Project Description: The applicant is requesting approval of a conditional use permit application for a 9,000 square-foot vehicle service business on 0.69-acres.

**Project/File:** **Blazek Diagnostic & Automotive / GC24-0007 / CUPFY2024-0006**  
This is a conditional use permit application for a 9,000 square-foot vehicle service business on 0.69-acres.

**Lead Agency:** Garden City

**Staff Approval:** April 18, 2024

## Site Plan

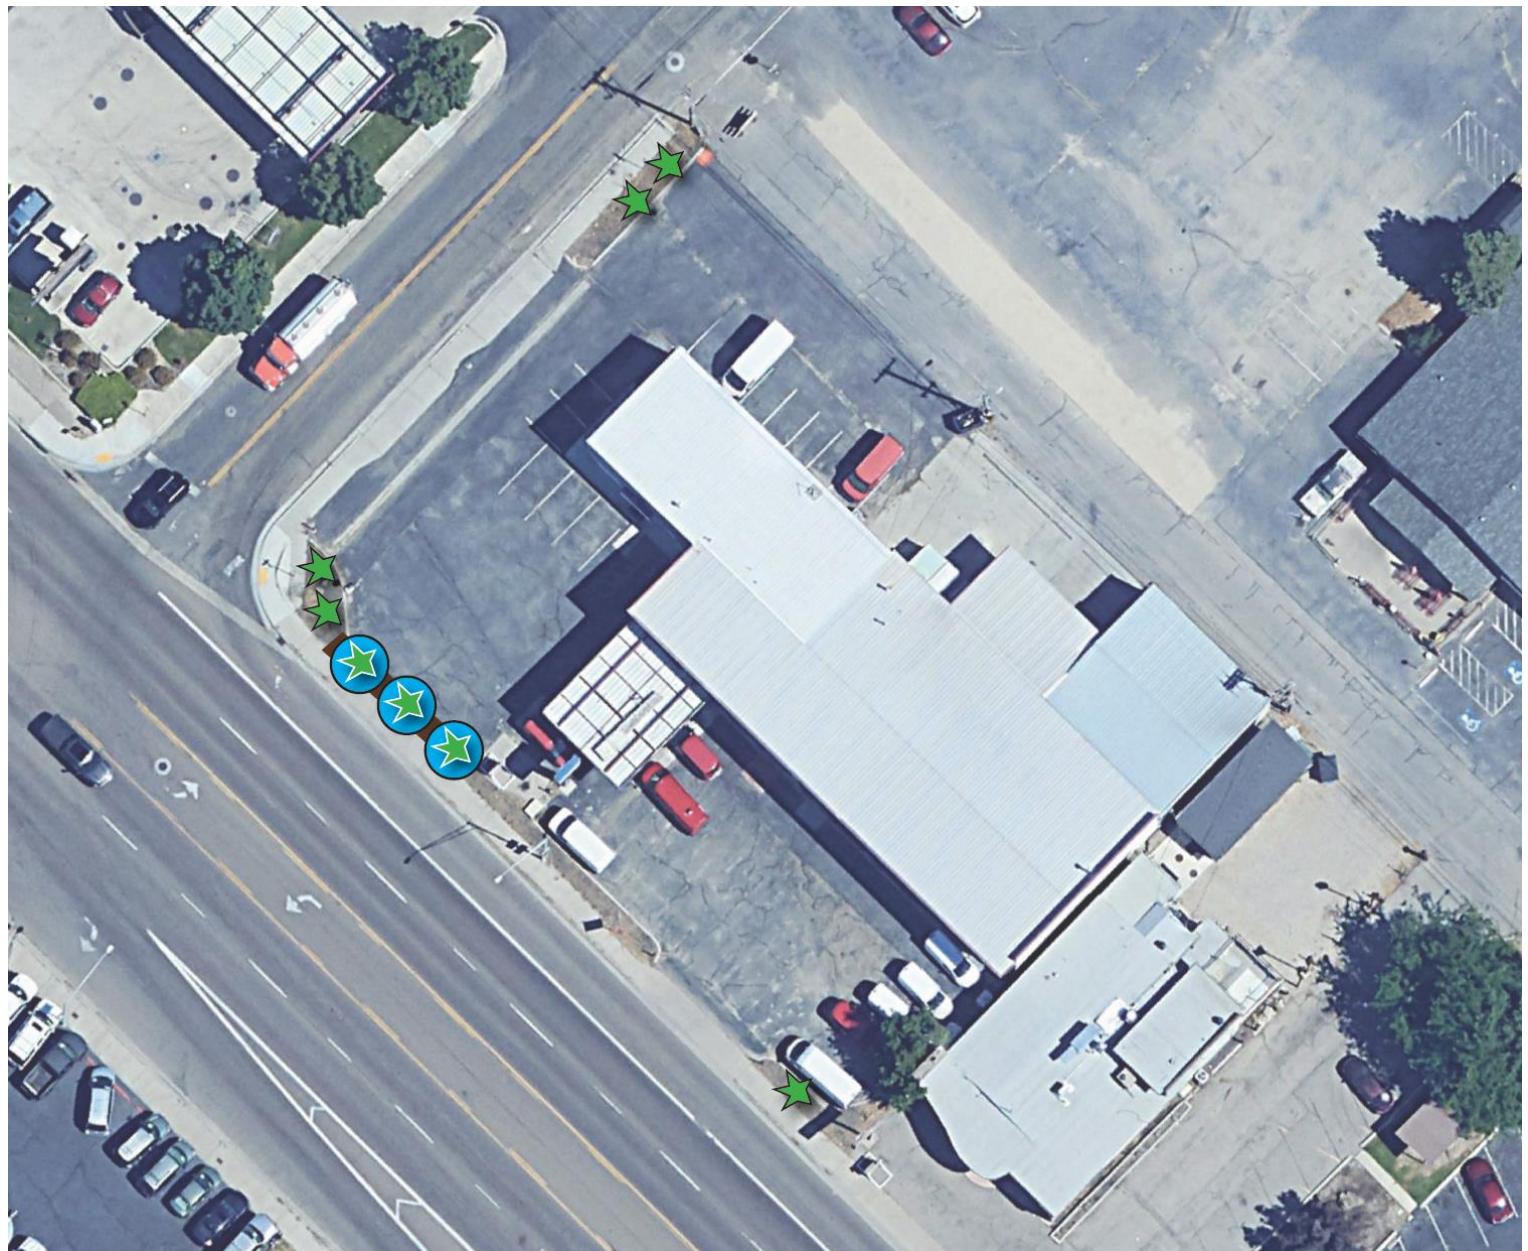
1. Repair or replace any damaged or deficient transportation facilities abutting the site on 37<sup>th</sup> Street in accordance with the current version of PROWAG.

2. Dedicate right-of-way to total 10-feet from centerline of the alley.
3. Install “No Parking” signs at the 37<sup>th</sup> Street/Osage Street intersection.

4. Provide 20-feet of back-up space from any parking structure to the back of the alley.
5. Close the existing 24-foot wide driveway on 37<sup>th</sup> Street located 100-feet east of Chinden Boulevard with vertical curb, gutter, and 5-foot wide attached concrete sidewalk to match the improvements on either side.

6. Reconstruct the existing 24-foot wide driveway on 37<sup>th</sup> Street located 137-feet east of Chinden Boulevard in accordance with PROWAG.
7. Submit civil plans to ACHD Development Services for review and approval. The impact fee assessment will not be released until the civil plans are approved by ACHD.

- b. **Applicant's Proposal:** The applicant is proposing to maintain both driveways.
- c. **Staff Comments/Recommendations:** The applicant's proposal does not meet District Driveway Location policy which requires driveway to be located 150-feet from arterial roadways and should not be approved, as proposed. The applicant should be required to close the existing 24-foot wide driveway located 100-feet east of Chinden Boulevard with vertical curb, gutter, and 5-foot wide attached concrete sidewalk to match the improvements on either side. Typically, the applicant should also be required to close the 24-foot wide driveway located 137-feet east of Chinden Boulevard as it does not meet District Driveway Location Policy. However, staff recommends the driveway remain located where it currently is, but be reconstructed in accordance with PROWAG to accommodate concerns regarding site circulation.
